<b>CITY OF WESTMINSTER</b>			
<b>PLANNING APPLICATIONS SUB-COMMITTEE</b>	<b>Date</b> 16 May 2017	<b>Classification</b> For General Release	
<b>Report of</b> Director of Planning		<b>Ward(s) involved</b> Abbey Road	
<b>Subject of Report</b>	<b>15-19 Blenheim Terrace, London, NW8 0EH,</b>		
<b>Proposal</b>	Variation of Conditions 1 and 20 of planning permission dated 26 April 2016 (RN: 14/12517/FULL) for demolition of existing buildings and erection of 3x5 bedroom five storey townhouses comprising basement, ground and three upper floors, formation of covered car parking area to rear and alterations to form a side access road; namely, to bring forward the front building line to align with the adjacent building to the south west, amend the detailed design of front and rear facades including revision of form of rear lightwell, addition of rooflights to the main roof and revision of internal layouts.

<b>Agent</b>	Gerald Eve		
<b>On behalf of</b>	Blenheim Property Holdings Limited		
<b>Registered Number</b>	16/08357/FULL	<b>Date amended/ completed</b>	31 August 2016
<b>Date Application Received</b>	31 August 2016		
<b>Historic Building Grade</b>	Unlisted		
<b>Conservation Area</b>	St Joh

**Approved front elevation (top)**

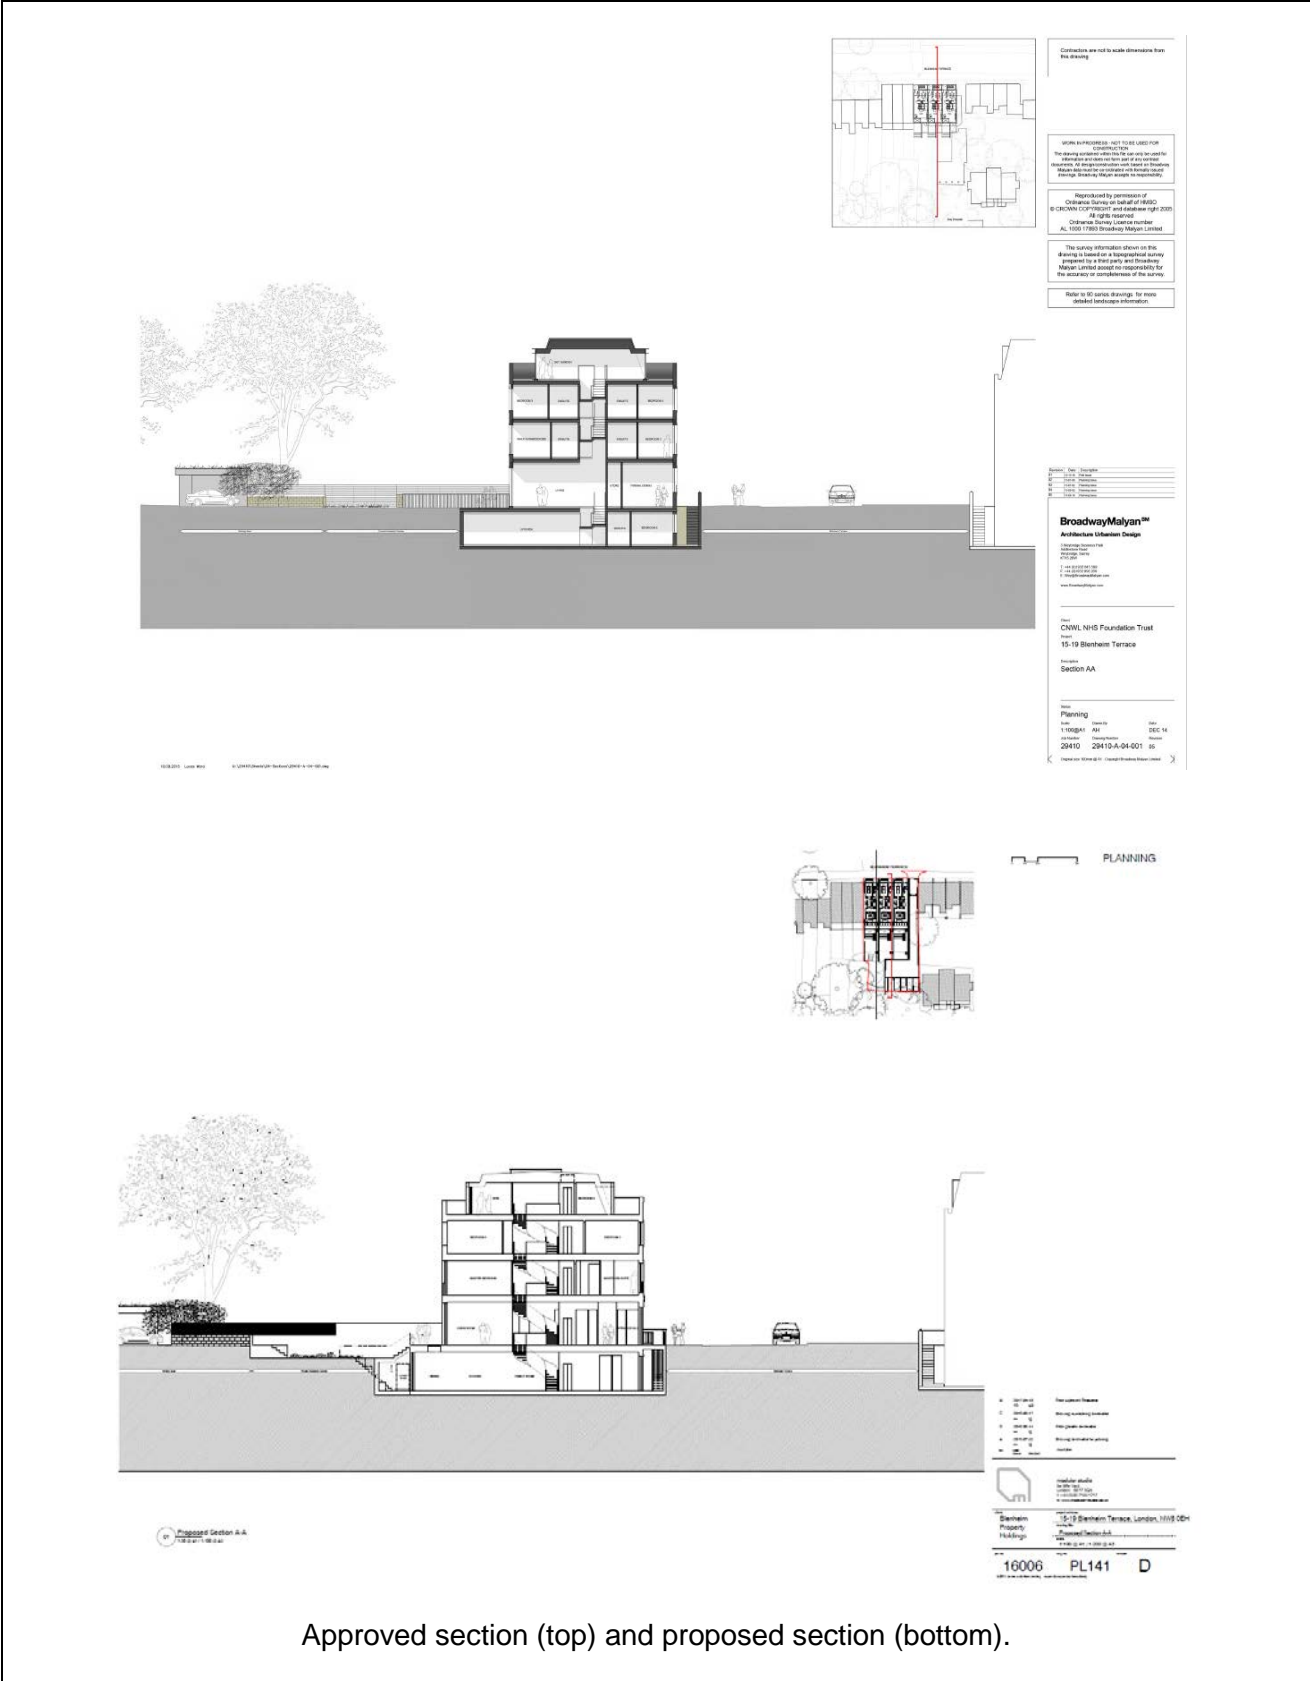
- A The cornice detailing increased in size and scale to relate to the neighbouring buildings.
- B The front doors mouldings/surroundings realigned with the elevation above. (Critical layout amendments)
- C The shadow gap terminates below the cornice.
- D The rooflights decreased dimensions, more subtle form.

The roof level cornice has been enlarged in the current scheme to ensure the front elevation of the new building maintains the hierarchy found to the front facade of neighbouring terraces. Whilst this amendment is acceptable in principle and will assist in softening the transition to the more traditionally detailed terrace to the west (Nos. 27 to 31 Blenheim Terrace), it is recommended that detailed elevations and sections of the roof level cornice, including a detail of the junction of proposed cornice with existing cornice to the neighbouring terrace, are secured by condition. The provision of these further details to ensure the detailing of the cornice is appropriate addresses the concerns raised by the St. John's Wood Society.

Approved section (top) and proposed section (bottom).

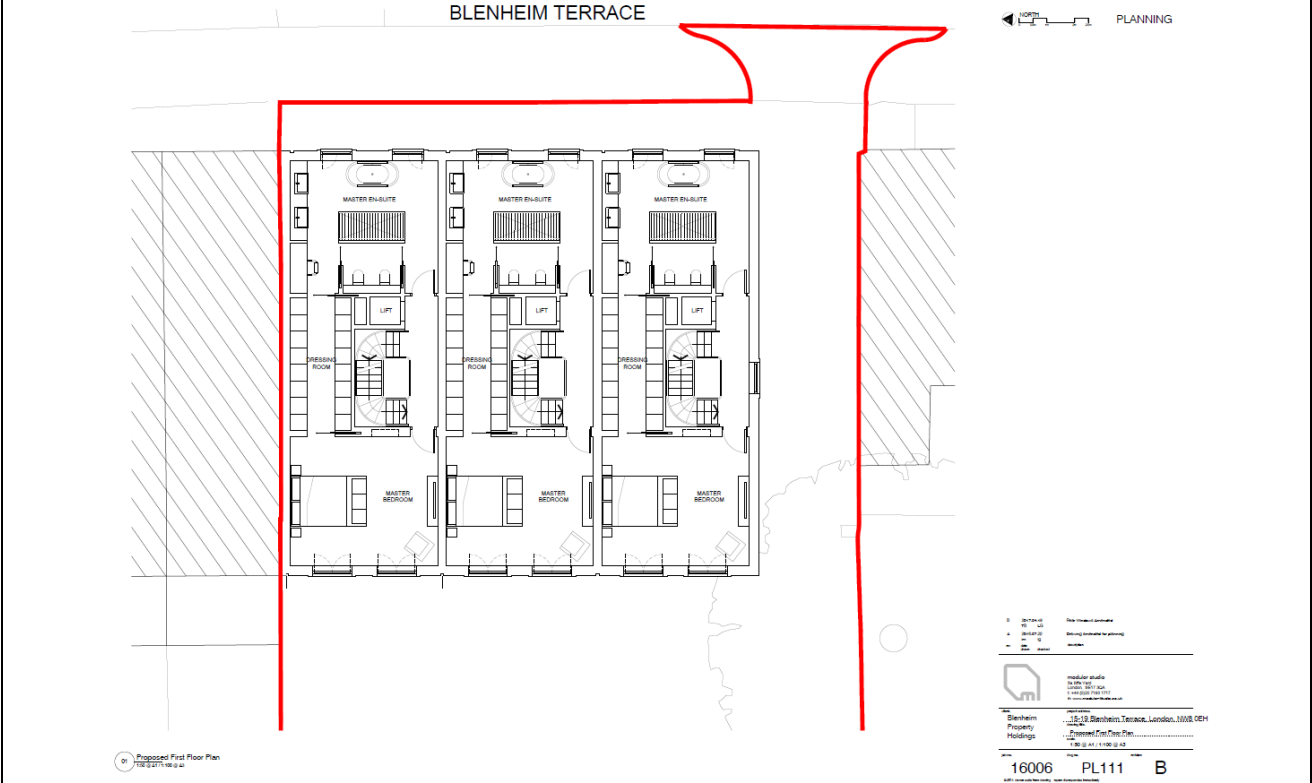
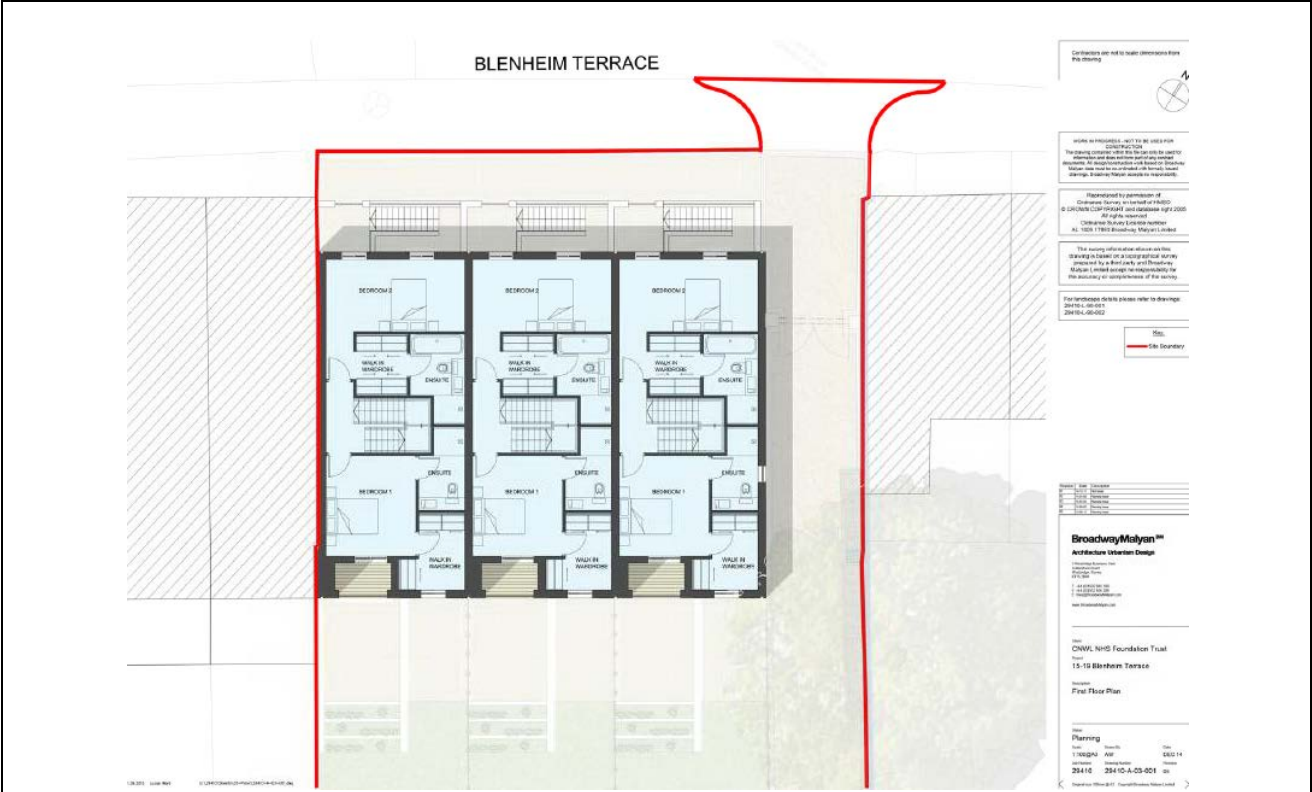
Consider there to be too much hard landscape, but note that there is no more than previously approved. Lowered ground levels in Section AA don't seem to match the ground floor plan (extends further into the RPA of the Sycamore tree in section). The footprint of the development has increased into the rear garden as previously there was ground level access into the rear garden and now there is basement access. Basement beyond the rear elevation does not have 1.0m soil depth and a drainage layer over it and and SUDS not provided; however, notes that the basement area affected is 'miniscule'. Section may indicate an increased incursion into the RPA of the Sycamore. Cannot support the loss of garden space and garden amenity in the conservation area due to the terraced lightwell.

The Arboricultural Manager also advises that he believes that the lower ground level lightwell seems to extend further in to the garden area in section than it does on plan. This was the case when the application was initially submitted; however, following revision of

the application (as referenced in the preceding paragraph) the projection into the rear garden is now limited to 6 metres and this is no greater than previously approved. Therefore the current application would not materially increase the impact of the development on the root protection area of the Sycamore tree, or any of the other trees, to the rear of the site.
